Shindaiwa Inc. Announces Recall of Backpack Blowers Due to Fire Hazard

Name of Product: Shindaiwa Backpack Blowers

IMPORTANT SAFETY RECALL

EB8510

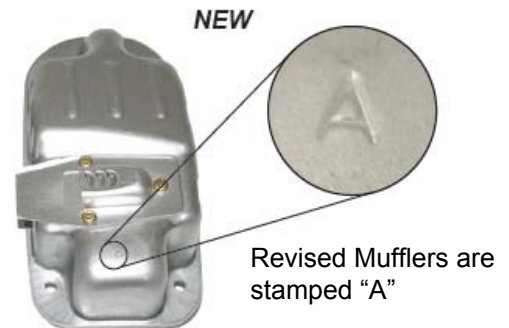
PROBLEM: Over extended hours of use, the EB8510 impeller can separate, causing a thrown object hazard to the operator and bystanders.

PROBLEM: Heat from a cracked muffler can cause melting of the fuel tank. This condition could damage the tank and create a fire hazard.

Revised Mufflers are stamped "A"

Owners of these units should contact your dealer immediately for impeller and muffler replacement. These upgrades will be performed at no charge to you.
